ADDRESS: 2517 Eastlake Ave E
Seattle, WA 98102

SDCI PROJECT NO: 3033787-EG

7.1 | OVERALL RENDERINGS 86

4.0 | EDG RESPONSE: ARCHITECTURAL CONCEPT

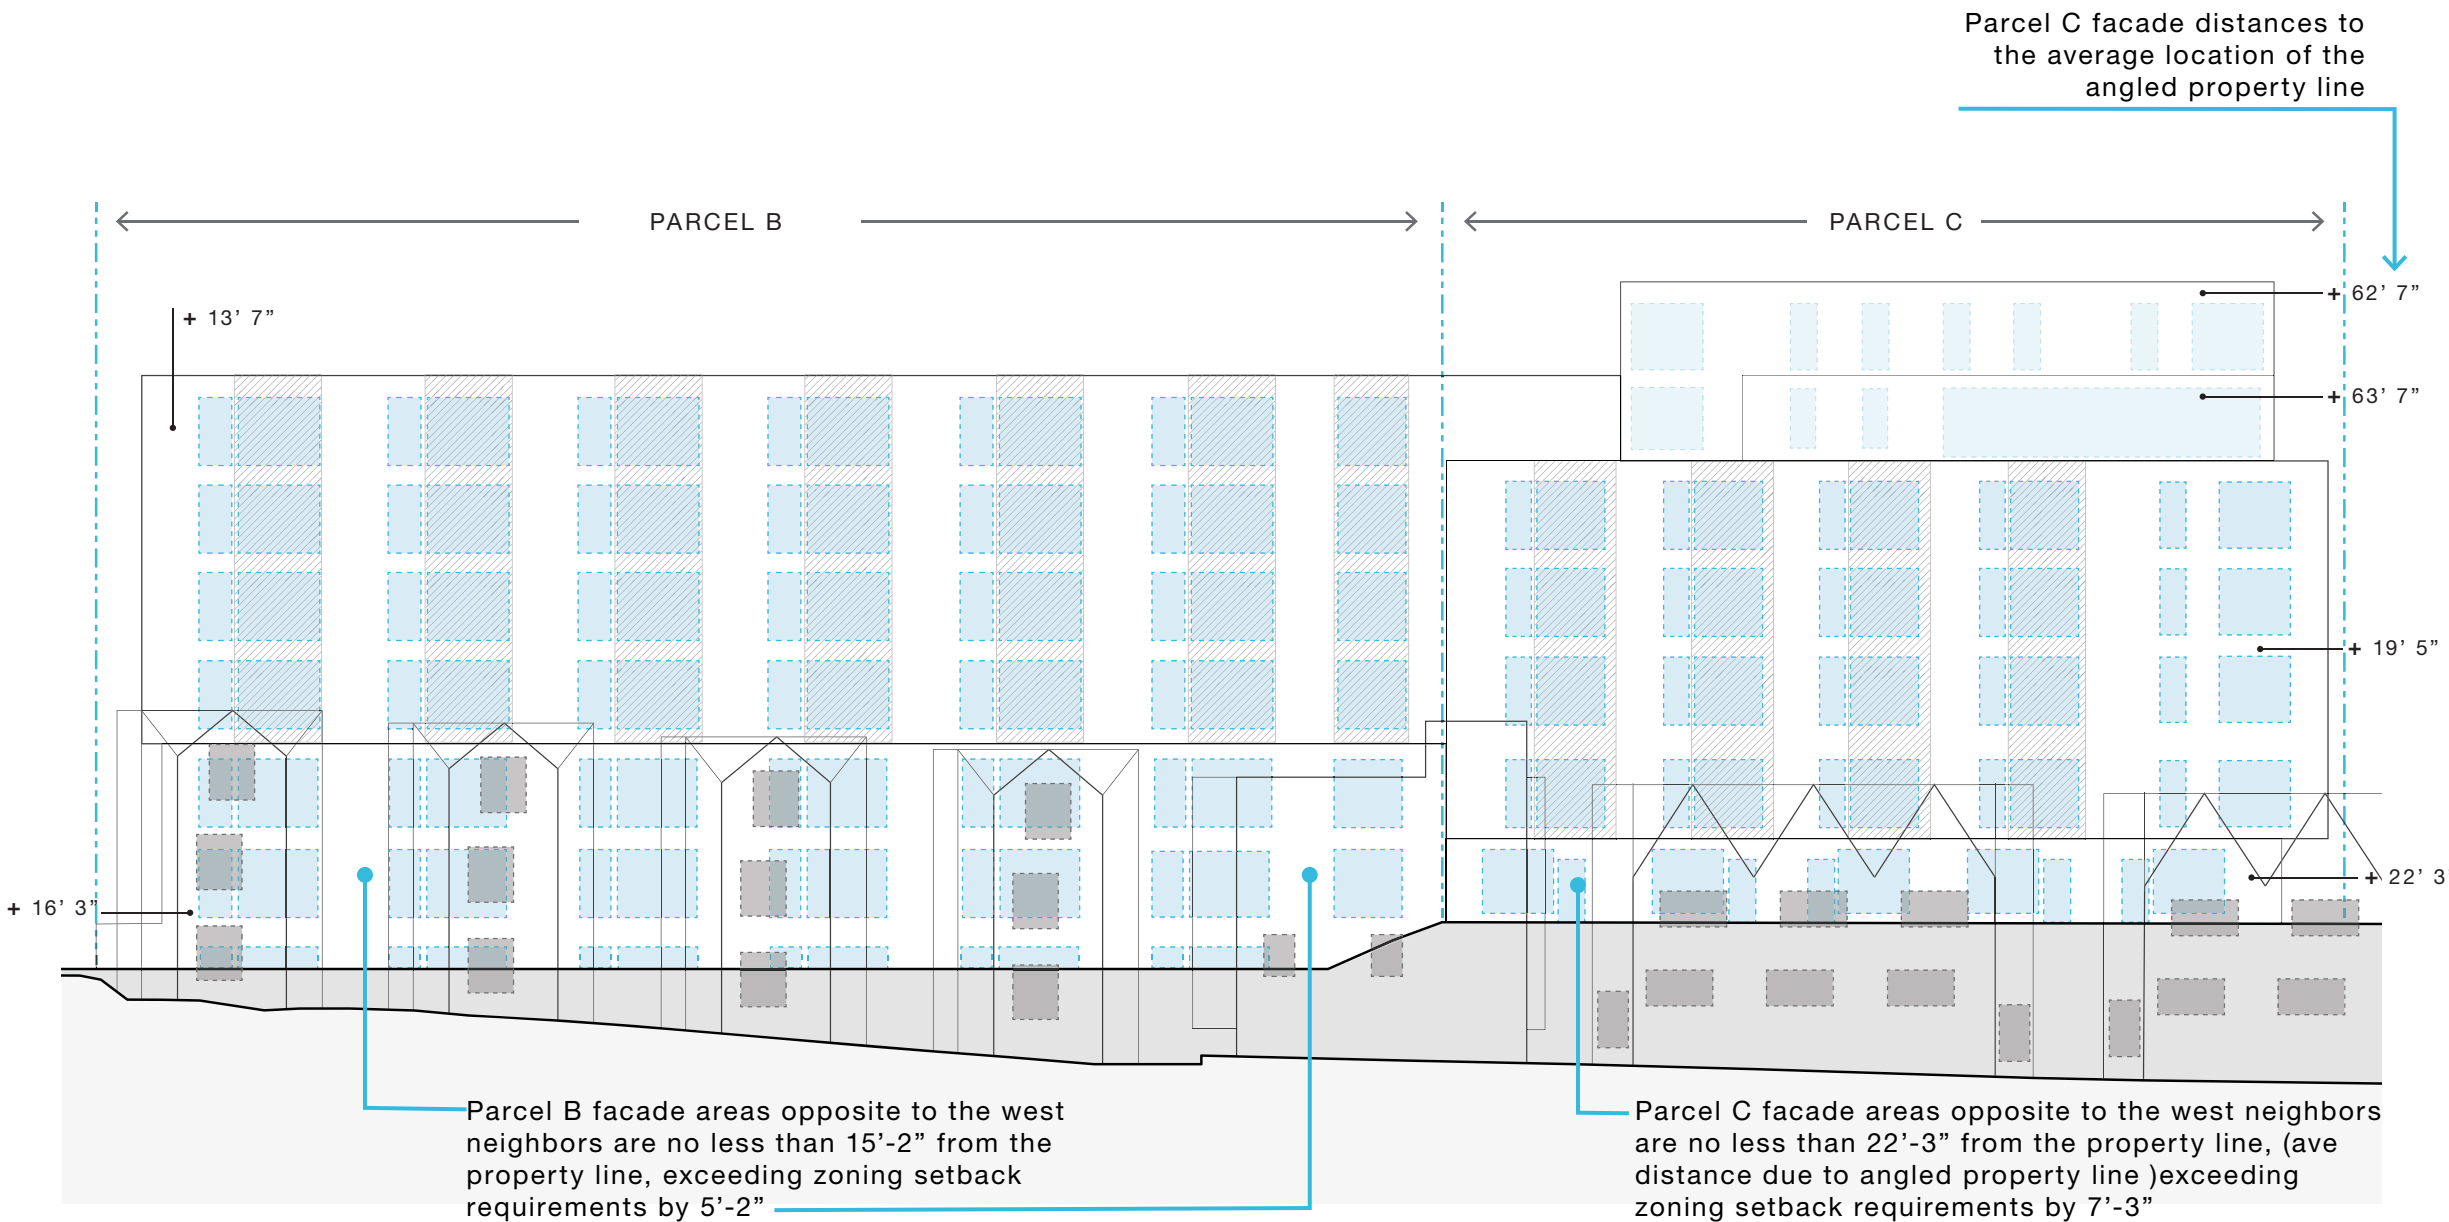
DESIGN REVIEW BOARD DIRECTION:
 2.a. Echoing public comment, the Board identified this edge and zone transition as a critical project element and agreed that the combination of topography and less-intensive zoning presented a unique challenge that would require careful composition. (CS2-D, CS2-D)

- DESIGN RESPONSE**
- + Reasonable compatibility of uses - Residential to residential.
 - + Three piece layered massing to reduce the scale differences between the structures. Upper level with significant setback.
 - + Proposal is at a higher elevation with an overall significant offset between the structures.
 - + Facade areas with windows opposite the neighbors are no less than 15'-2" for Parcel B and 19'-11" for Parcel C from the property line; minimal overlap of vision glass between the structures.
